Staff Summary Report

SUBJECT: Hold a public meeting for a Development Overlay for FOUNTAINHEAD OFFICE PLAZA, located at 1625 W Fountainhead Parkway.

DOCUMENT NAME: DRCr_FountainheadOfficePlaza_012709

DPR08237 – Development Plan Review including site plan, building elevations and landscape plan.

SITE PLAN

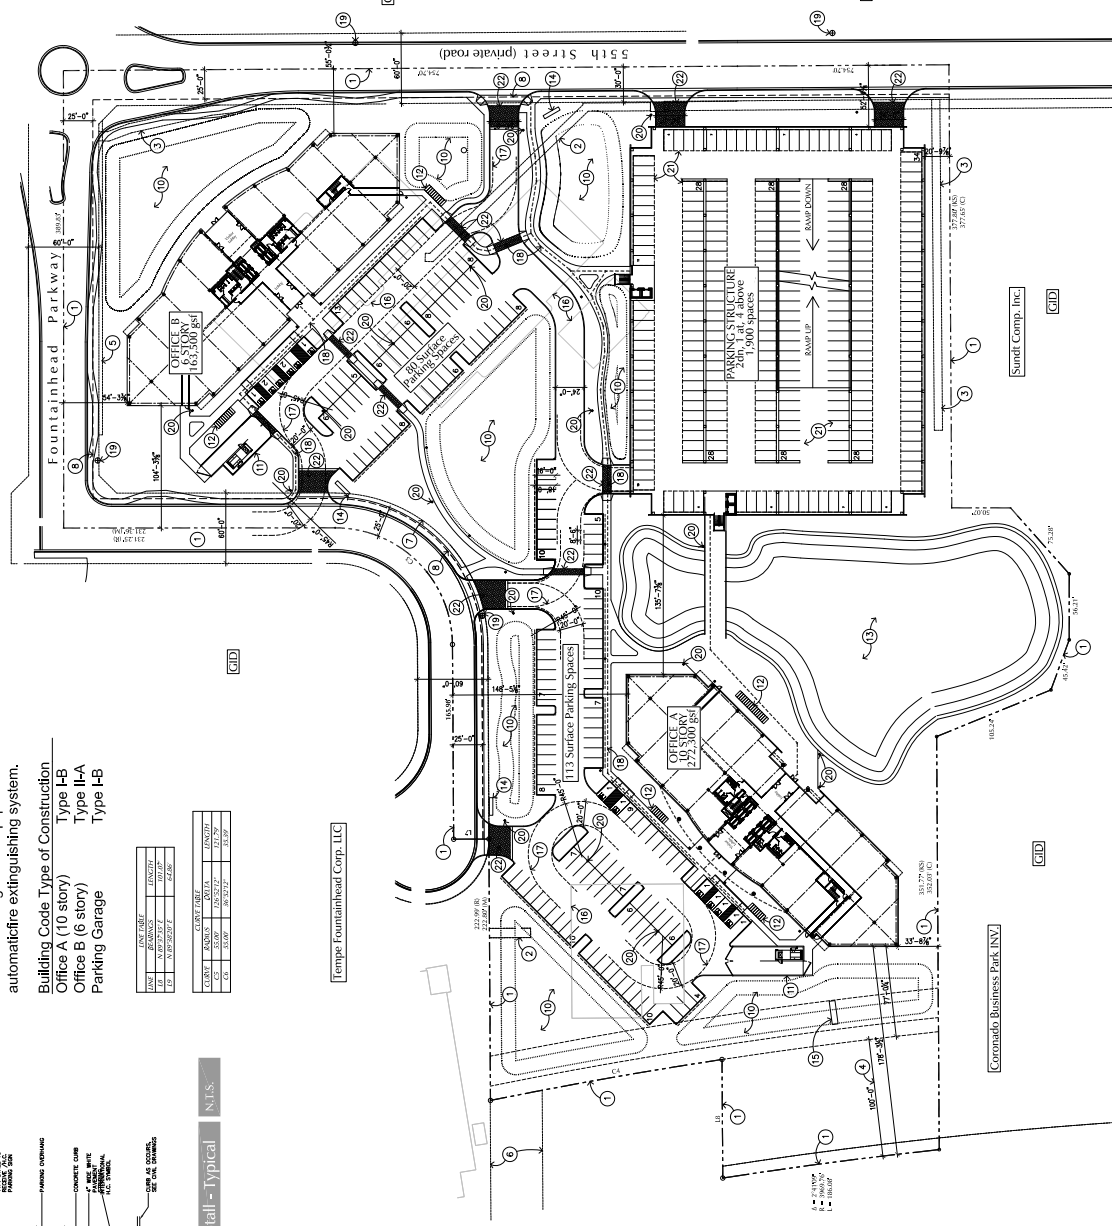
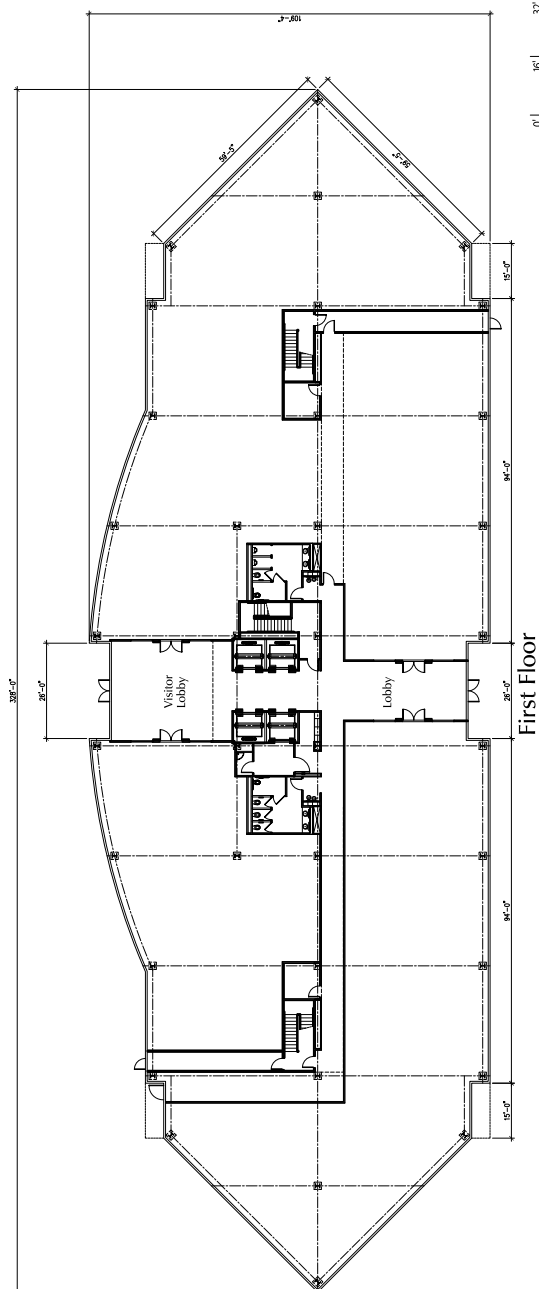
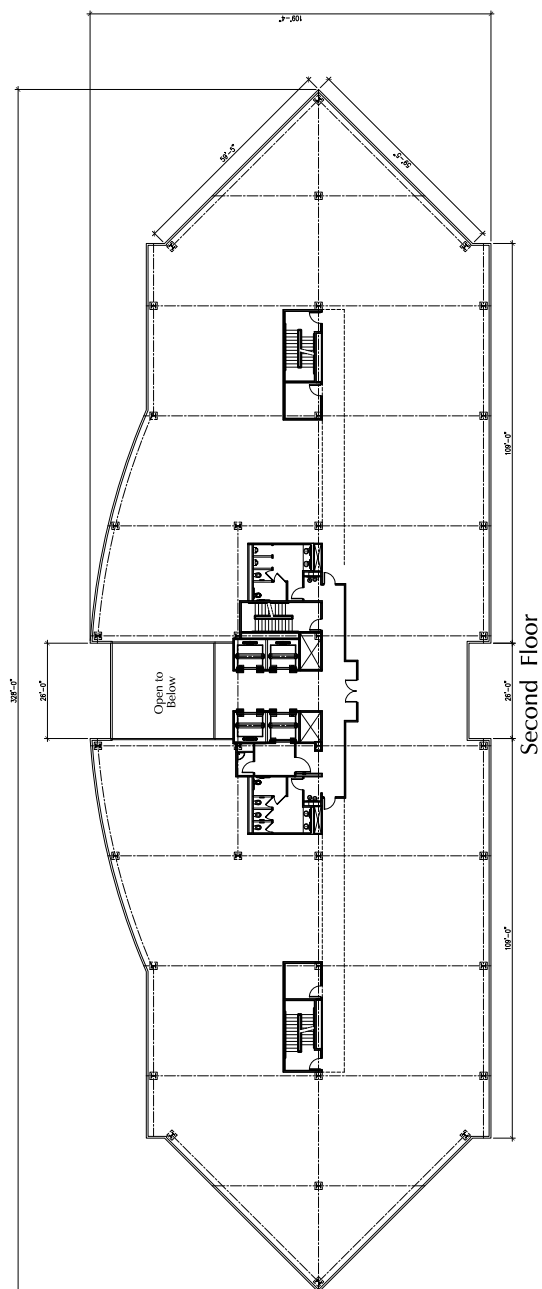
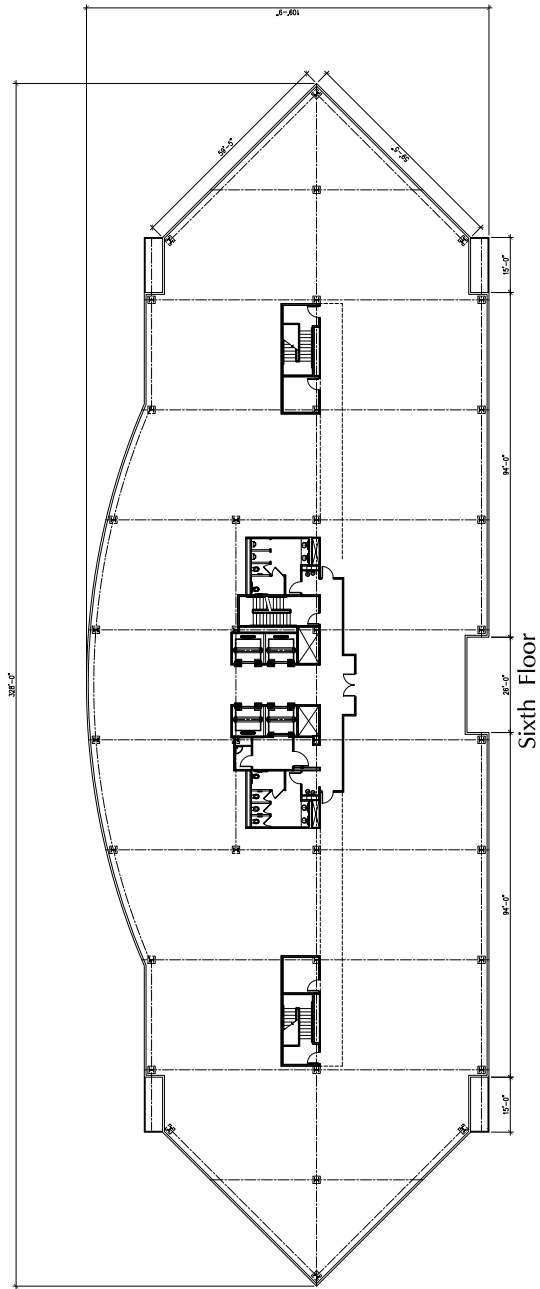
4. Provide service yard and mechanical yard walls that are at least 8'-0" tall as measured from adjacent grade and are at least the height of the equipment being enclosed, whichever is greater. Verify height of equipment and mounting base to ensure that wall height is adequate to fully screen the equipment. Locate electrical service entrance sections inside the service yard, as indicated.

5. If gates are used, provide gates of steel vertical picket, steel mesh, steel panel or similar construction. Where a gate has a screen function and is completely opaque, provide vision portals for visual surveillance. Provide gates of height that match that of the adjacent enclosure walls. Review gate hardware with Building Safety and Fire staff and design gate to resolve lock and emergency ingress/egress features that may be required.

6. Provide upgraded paving at each driveway apron consisting of unit paving. Extend unit paving in the driveway from the back of the accessible public sidewalk bypass to 20'-0" on site and from curb to curb at the drive edges.

9. Shade canopies for parking areas:
 - a. Provide an 8" fascia for the canopy structure.
 - b. Maximum 75% light reflectance value shall also apply to the top of the canopy.

- c. Conceal lighting conduit in the folds of the canopy structure and finish conduit to match.

ELEVATIONS
6 STORY

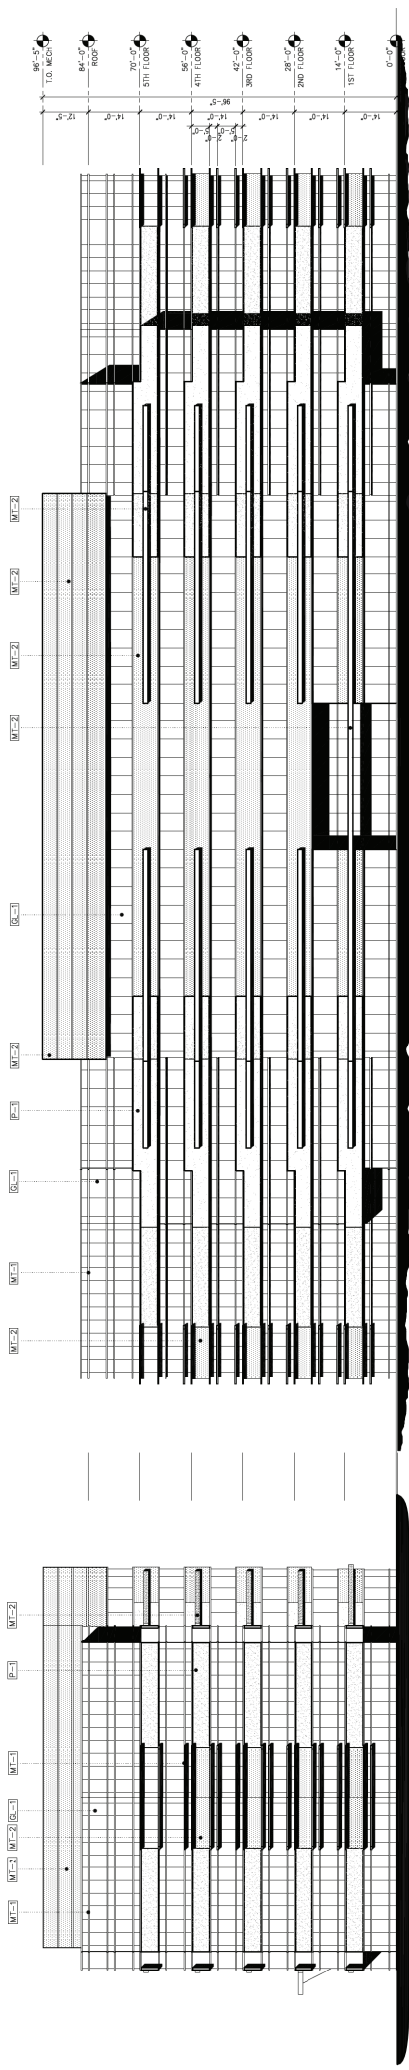
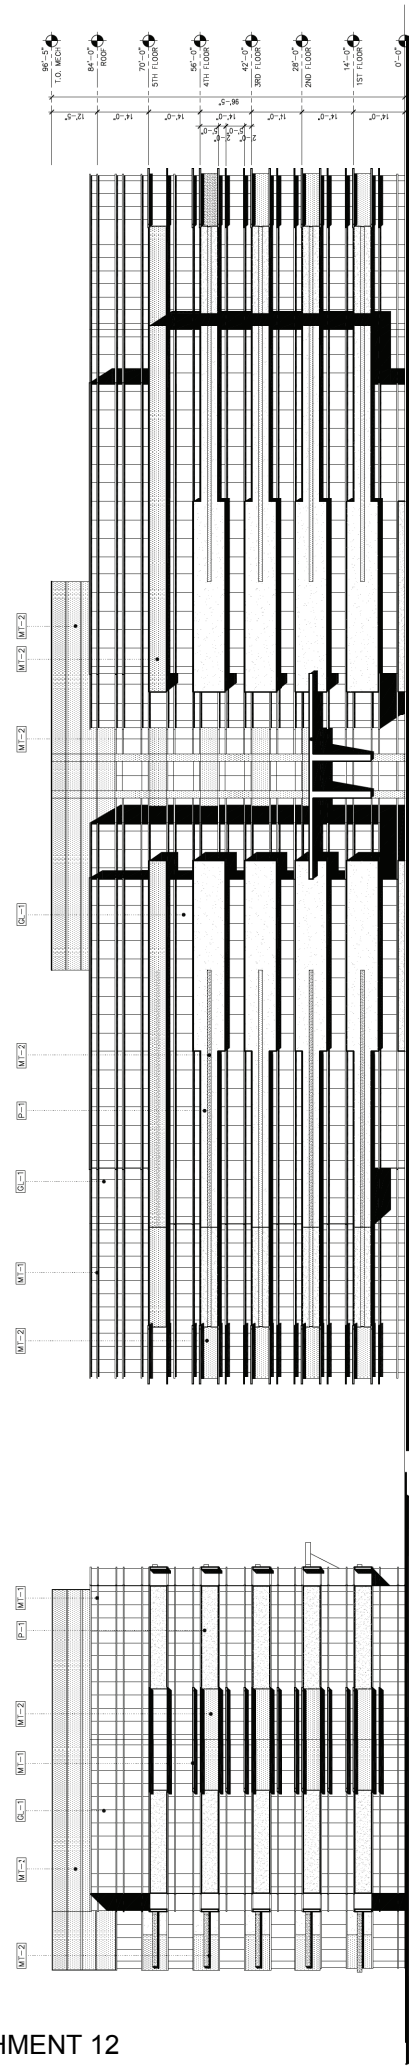
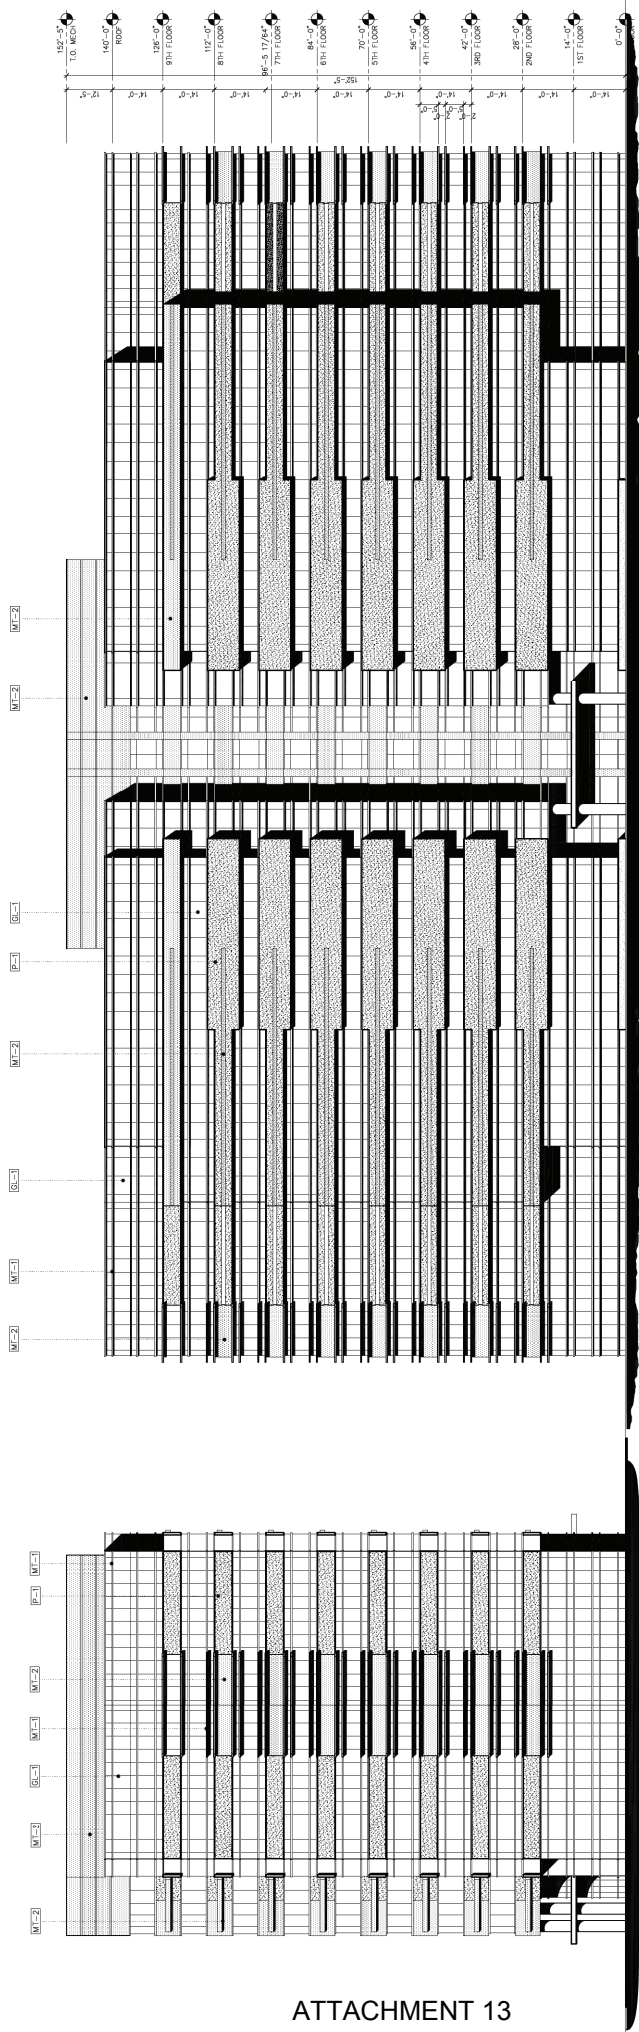
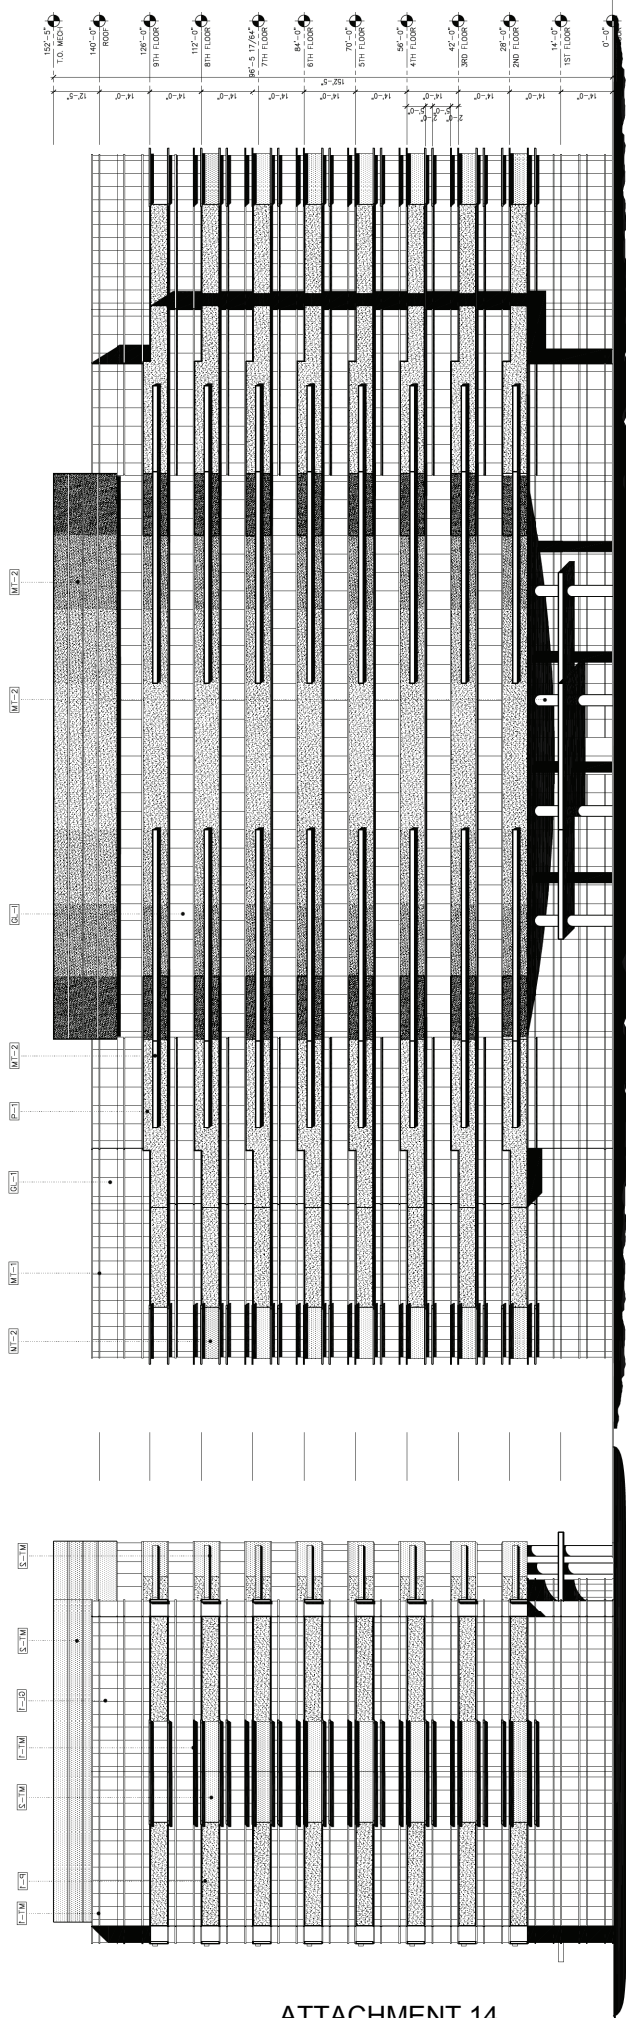
13. The materials and colors are approved as presented:
Integral Colored Concrete – to match Dunn Edwards paint color DE6242 Wells Grey LRV 43
Metal panel painted to match ATAS 70 Clear
Clear anodized aluminum frame – to match Arcadia #11/Clear AC-2
1" Insulated glass to match Versalux Blue 2000T Subdued Silver Reflectance
Provide main colors and materials with a light reflectance value of 75 percent or less. Specific colors and materials exhibited on the materials sample board are approved by planning staff. Submit any additions or modifications for review during building plan check process.

14. Provide secure roof access from the interior of the building. Do not expose roof access to public view.
15. Conceal roof drainage system within the interior of the building.

16. Incorporate lighting, address signs, and incidental equipment attachments (alarm klaxons, security cameras, etc.) where exposed into the design of the building elevations. Exposed conduit, piping, or related materials is not permitted.
